Docket Number:	23-OPT-02
Project Title:	Darden Clean Energy Project
TN #:	261491
Document Title:	Stormwater Management Responses
Description:	This document provides additional information on stormwater management in responses to questions received from the CEC.
Filer:	Becky Moores
Organization:	Intersect Power
Submitter Role:	Applicant
Submission Date:	1/31/2025 12:17:14 PM
Docketed Date:	1/31/2025

Stormwater Management

DRAWING TITLE
SCHEMATIC
DETENTION
BASIN DESIGN

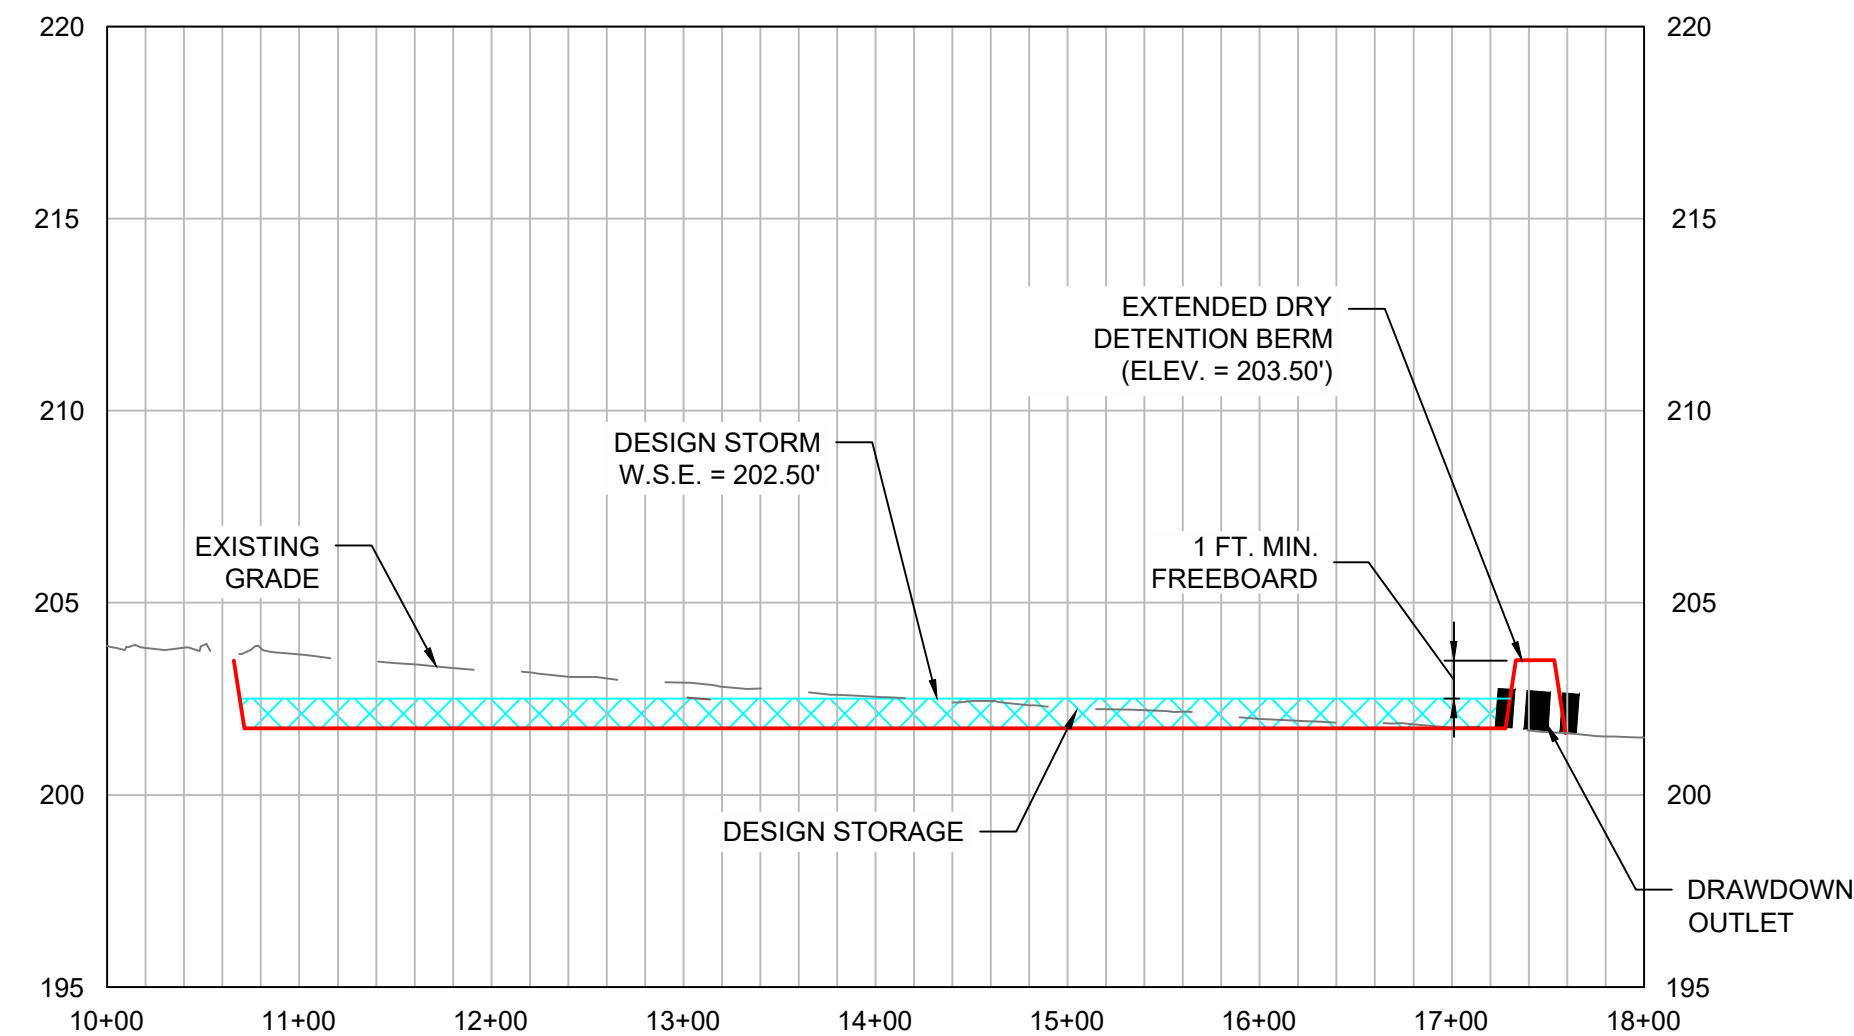
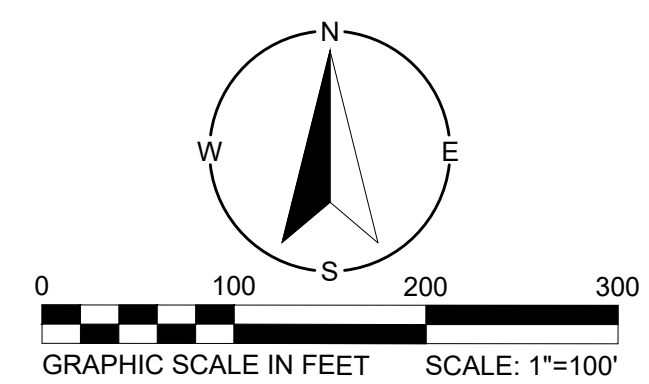
Question 8: *The Preliminary Stormwater Plan, Stormwater Management Practices section states that the detention basins will be designed with a minimum 1 foot of freeboard from the top of the berm. What design element will ensure this freeboard? Would it be possible to get a schematic design drawing of the typical detention basin?*

Response 8: The 1-foot freeboard will be met by adjusting the basin size, berm elevation, and outflow control. These will be modeled using modeling software such as HydroCAD or equivalent. Attached is a schematic showing a concept that could be used which includes a detention basin with a berm, outflow culvert, and berm spillway. Other basin designs and controls could be used in the design, and this concept is subject to change based on final Project layout and stormwater modeling.
